**Amendment to Section V.A.
Summerlin West Community Association
Design Guidelines and Standards, December 1, 2001**

Below is an amendment to the Summerlin West Community Association Design Guidelines and Standards, December 1, 2001 Section V. Subsection A., LANDSCAPING, Paragraph 1 (g) and Paragraph 5 (f). Please insert the following into your current guideline document, page 8. (*The amended language is in bold italics*).

**Amendment to Section V.C.
Summerlin West Community Association
Design Guidelines and Standards, December 1, 2001**

**Amendment to Section V.G.
Summerlin West Community Association
Design Guidelines and Standards, December 1, 2001**

EXHIBIT 7

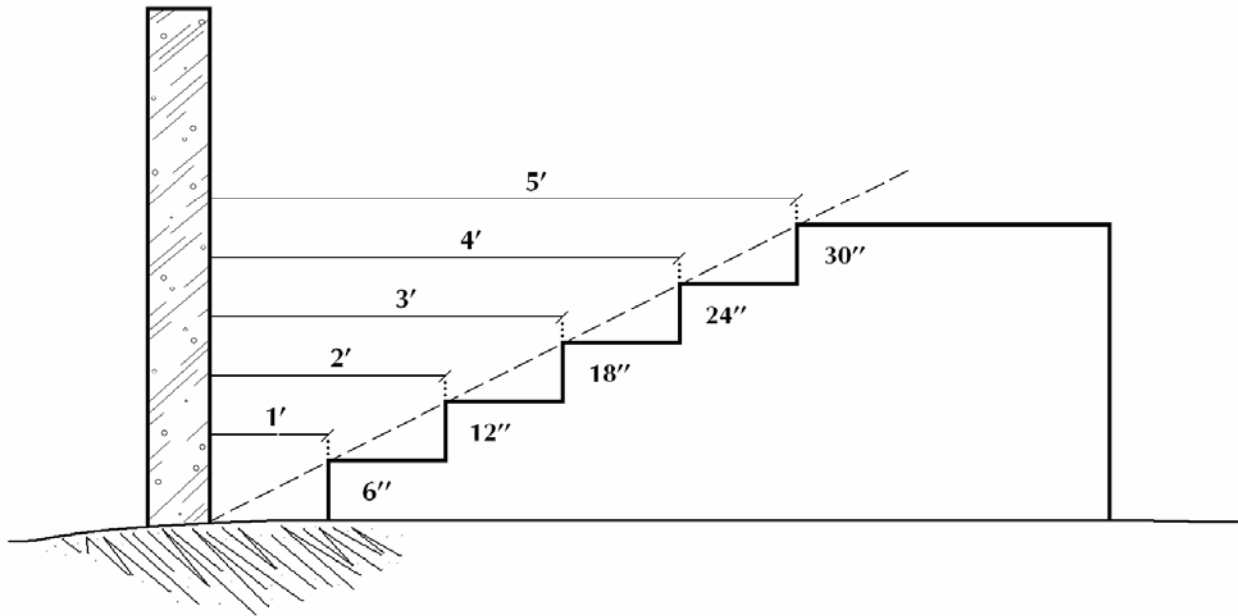
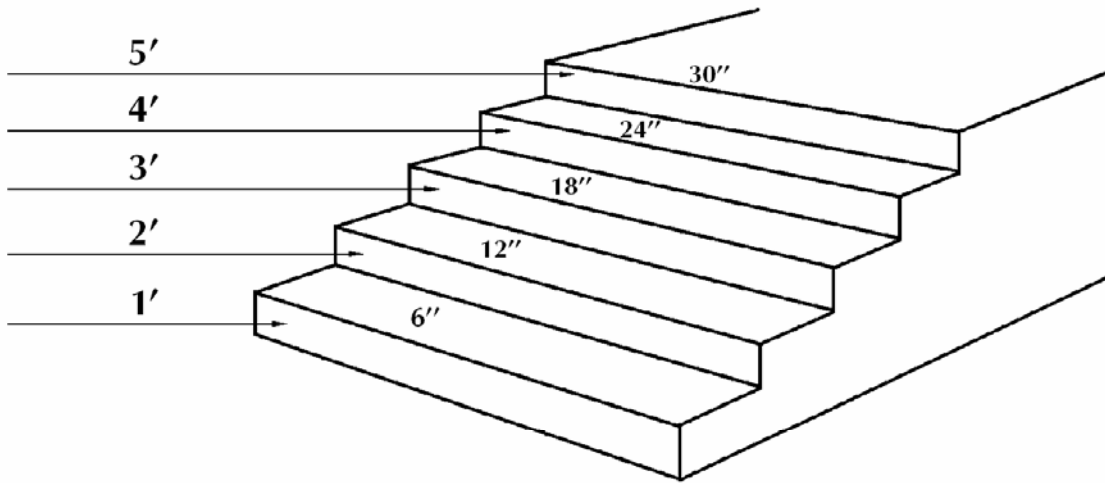
6. Raised observation decks or patios are allowed in the rear yard only.
- a. **Raised decks originating at grade level of the residence must be setback from all perimeter walls a minimum distance of twice the total height of the deck above the grade of the building pad. Except as noted in item “b” below, no deck may exceed thirty inches (30”) in height above the grade of the building pad. (refer to Exhibit 7).**
